HARTZELL PROPELLER INC.
SERVICE BULLETIN
HC-SB-61-383
Propeller - 103559 Hub Shot Peening

- (1) Hartzell Propeller Inc. has revised the shot peening requirements for the 103559 hub unit used on the affected propellers.
 - (a) Hartzell now requires the surface of the hub flange radius and the bulkhead mounting area to be shot peened.
 - 1 Previously, Hartzell required masking material to be applied to the hub flange radius and bulkhead mounting area before shot peening.

Shot Peen Masking for 103559 Lightweight Turbine Aluminum Hub
Figure 1

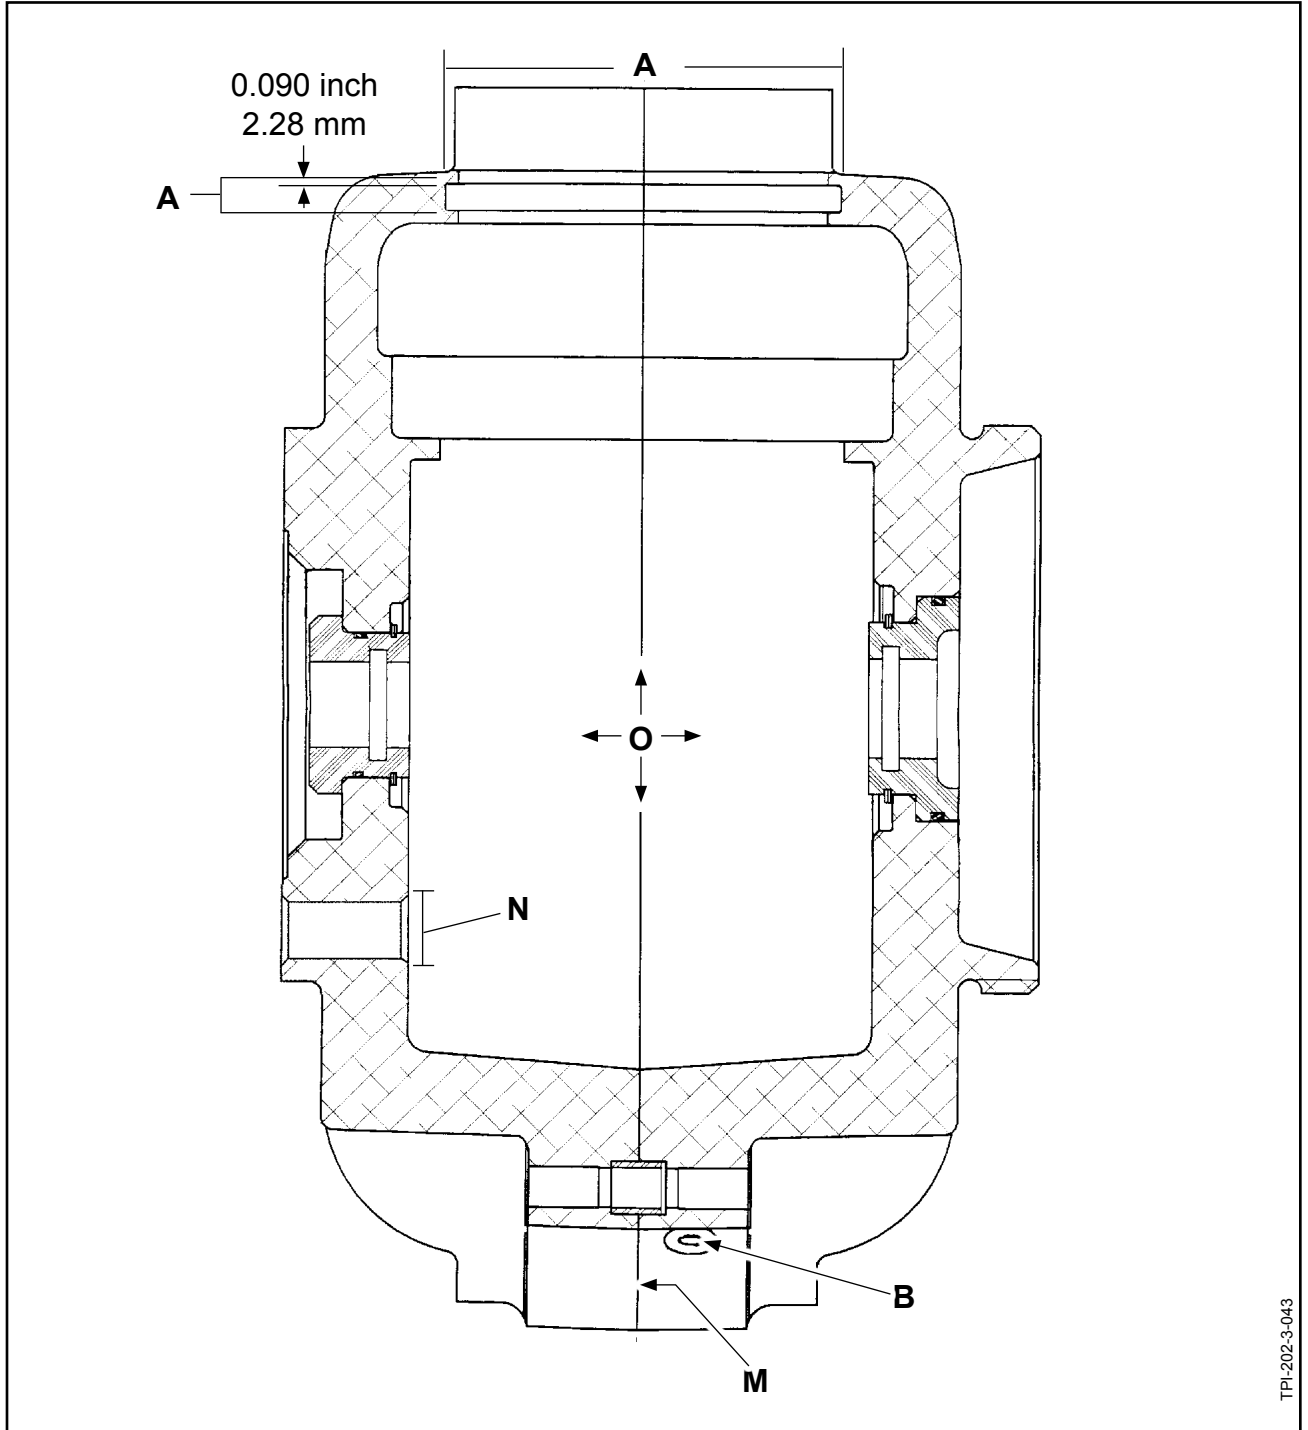
AREA	FIGURE	REQUIREMENT	SHOT PEEN
A	Figure 1	Do not shot peen within 0.090 inch (2.28 mm) of the blade O-ring seal groove on each hub socket.	X
B	Figure 1	Mask the threaded lubrication fitting holes for all shot peen operations. Incomplete coverage is acceptable around masked holes to 0.375 inch (9.52 mm) maximum wide area. There are four holes on each hub half.	X
C	Figure 2	Mask the bulkhead attachment threaded holes for all shot peen and paint operations. Incomplete coverage for shot peen is acceptable around masked holes to 0.090 inch (2.28 mm) maximum wide area. There are eight holes on engine-side hub half.	X
D	Figure 2	Mask the hub clamping bolt through holes for all shot peen operations. Incomplete coverage is acceptable around masked holes to 0.090 inch (2.28 mm) maximum wide area. There are 20 holes on each hub half.	X
E	Figure 2	Mask the threaded balance weight holes for all shot peen operations. Incomplete coverage is acceptable around masked holes to 0.375 inch (9.52 mm) maximum wide area. There are eight threaded holes on each hub half.	X

Shot Peen Masking for 103559 Lightweight Turbine Aluminum Hub
Figure 2

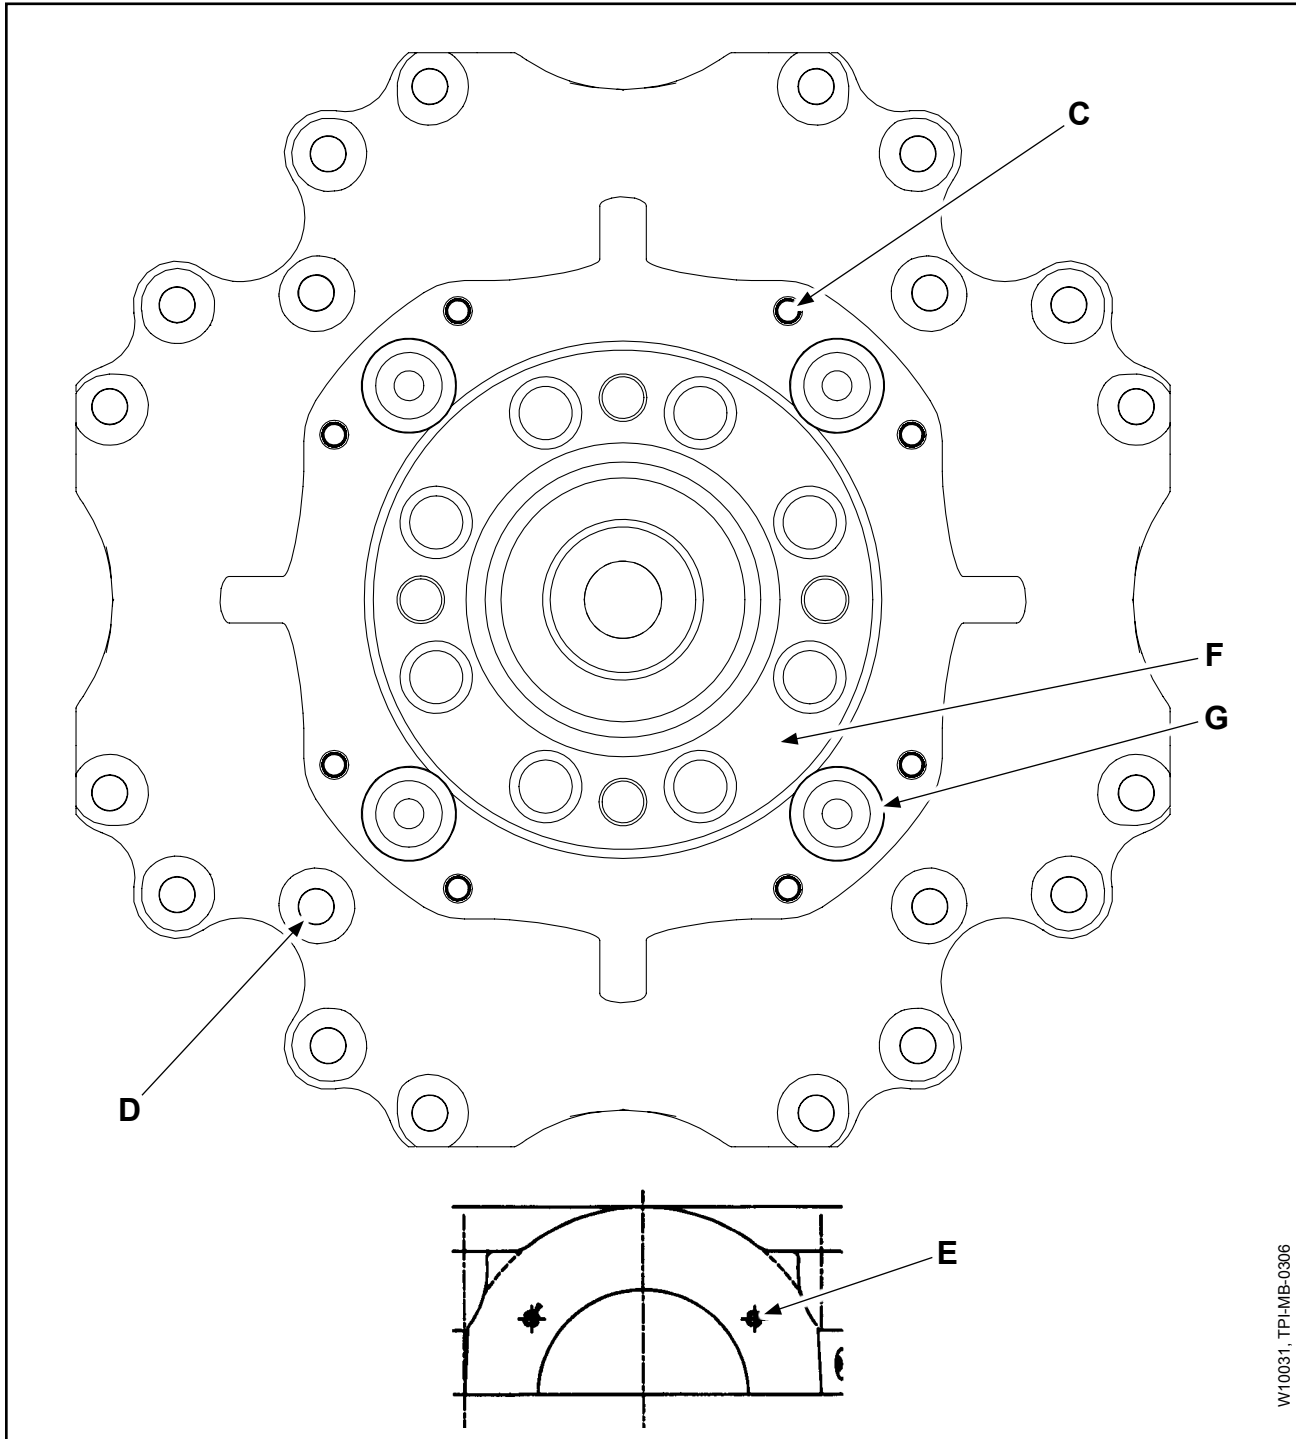
F	Figure 2	Mask the engine flange mating surface on the engine-side hub half for all shot peen and paint operations.	X
G	Figure 2	Mask the spring retainer 1.00 inch (25.4 mm) diameter to 0.325 ±0.025 inch (8.25 ±0.635 mm) height. Deburr edges after shot peening. There are four beta spring retainer holes on the engine-side hub half.	X
H	-	not applicable for shot peening	-
I	-	not applicable for shot peening	-
J	Figure 3	Mask the cylinder-side hub half from the centerline of the hub out to include the flat part of the hub for all shot peen operations.	X
K	-	not applicable for shot peening	-
L	-	not applicable for shot peening	-
M	Figure 1	Mask the hub parting surface for all shot peen and paint operations.	X
N	Figure 1	For the 103359 hub only, mask the 8 mounting bolt through holes that intersect with the inside surface.	--
O	Figure 1	Except for the hub bearing blade pockets, the inside surfaces are not shot peened. Masking for shot peening is specified in Figure 4 and Figure 5.	X

Shot Peening of 4 Blade Lightweight Turbine Aluminum Hubs
Figure 4

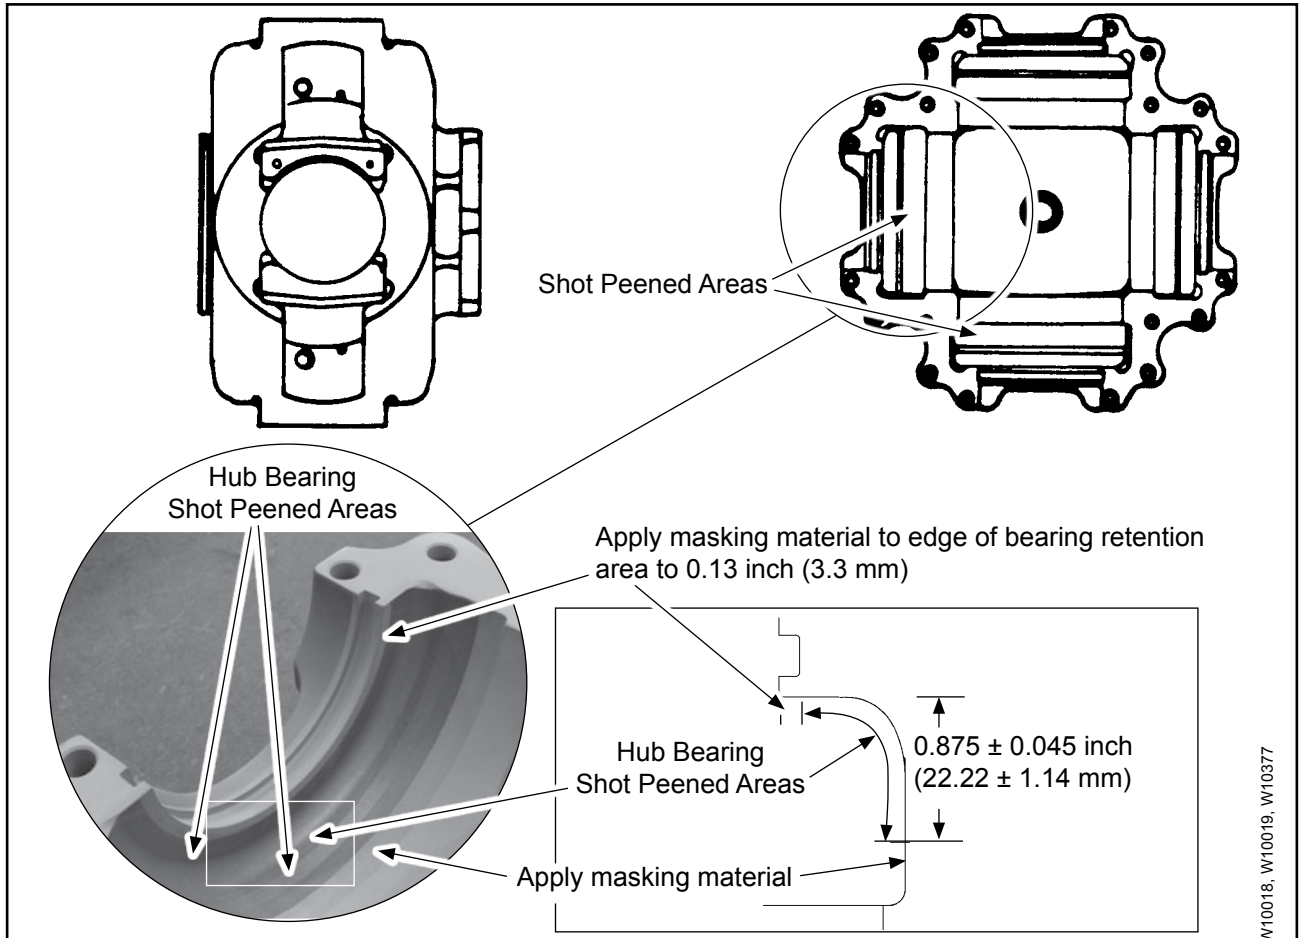
Shot peen the inside hub bearing area only, as shown in the figure above. Shot peen the entire outside of the hub, **EXCEPT: DO NOT** shot peen the flange face, O-ring grooves, bolt through holes, or any threaded areas. For additional masking requirements, refer to Table 1 in this Service Bulletin.

<u>Description</u>	<u>Shot Size*</u>	<u>Almen Type</u>	<u>Intensity</u>
All models of the 4-blade aluminum hub: Outside and Inside	S330	A	0.010 - 0.014

Almen Strip Locations for a 4 Blade Lightweight Turbine Aluminum Hubs
Figure 5

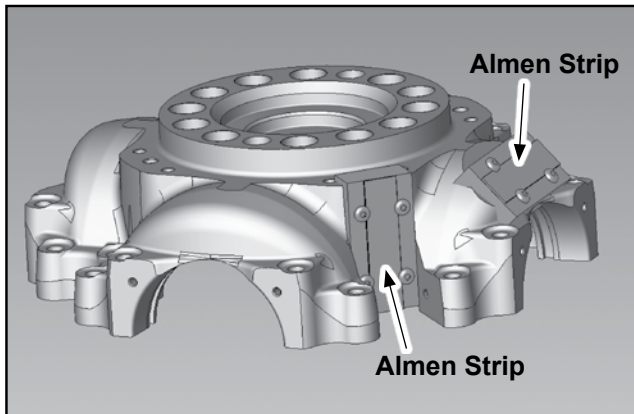
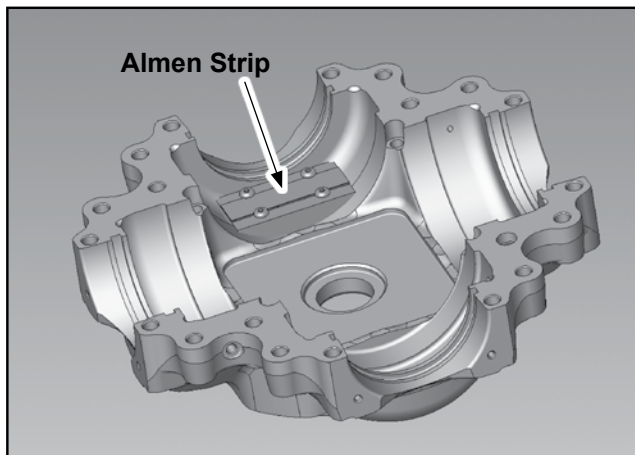
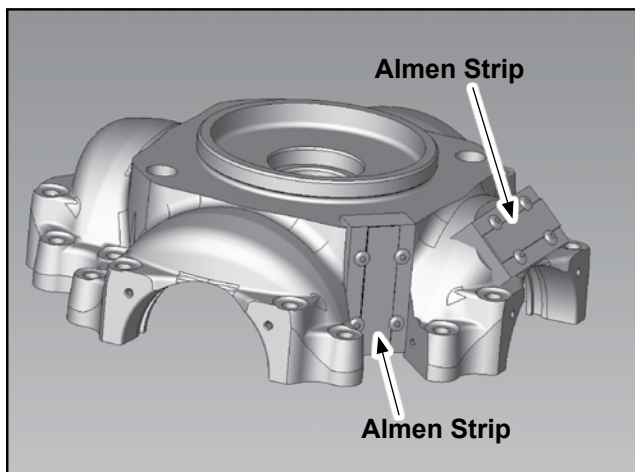
4 Blade Aluminum Hub, Internal
This location applies to each hub half.

4 Blade Aluminum Hub, Cylinder Half
There are a total of six Almen strip locations for the 4 blade aluminum hub.
